Burgos Wind Farm Project

The Philippines

Technical Desk Review

Figure 1 Wind rose and wind-speed histogram of measured data March 2001-February 2002

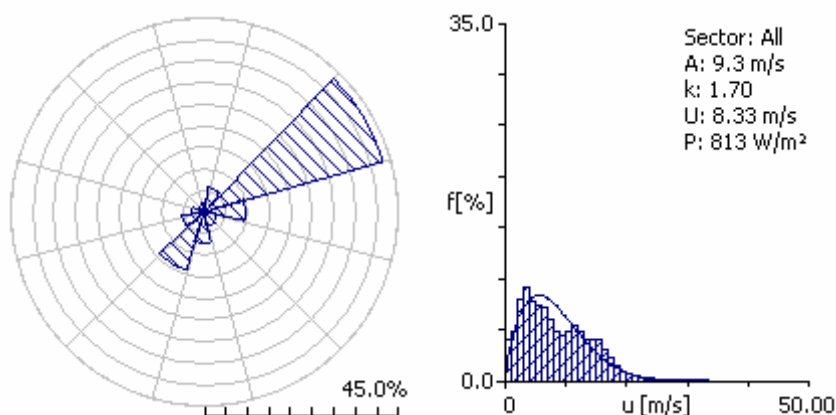
marked data points removed, we are unable to find the same wind distribution as in the PNOC-EDC feasibility update report suggesting that we are not using exactly the same data. The discrepancies are however modest 0.2% for both average wind speed and wind power density. Our results are shown in Figure 1 and Table 3.

Figure 4 Wind resource map of Gross AEP with directional distributions and wake losses at turbine positions.

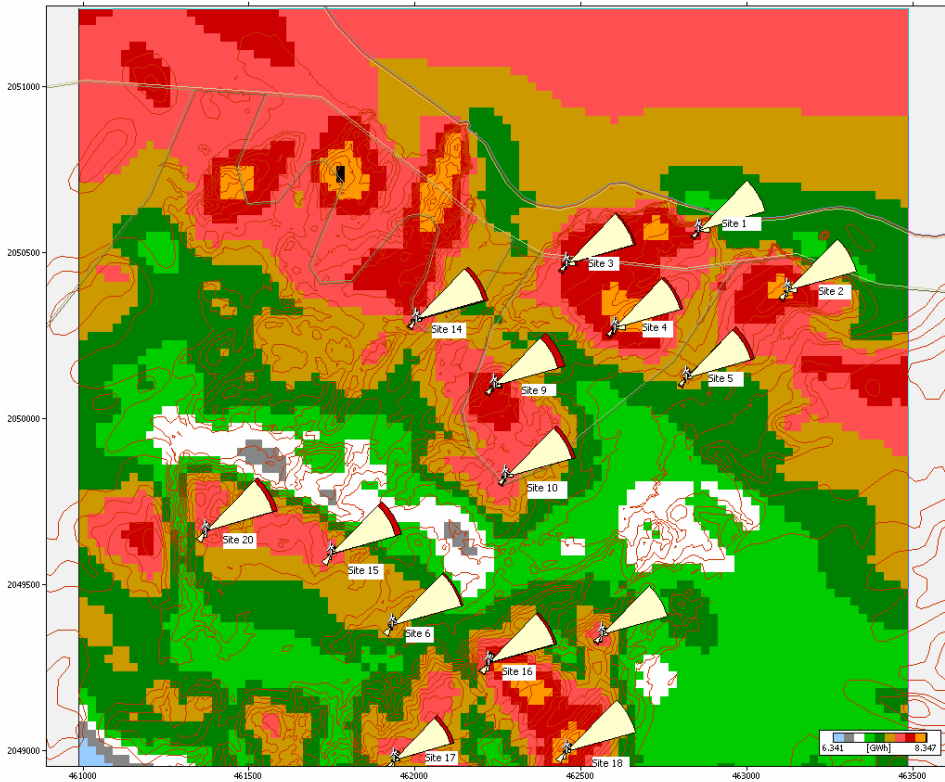
Figure 4 shows a wind resource map of gross AEP for a Vestas V80 2 MW turbine with 67m hub height. Also shown are the directional AEP distributions at the turbine positions with correction for wake losses. The layout is a reasonable compromise between having turbines near local optima in the spatial wind resource distribution and keeping a proper distance between the turbines. Further optimization might be possible, e.g. by moving turbine site 1 westward near a local optimum or moving

turbine 9 backward to reduce its relatively high wake loss. These adjustments will only be fine-tuning since the turbine AEP are not too different, see Figure 5
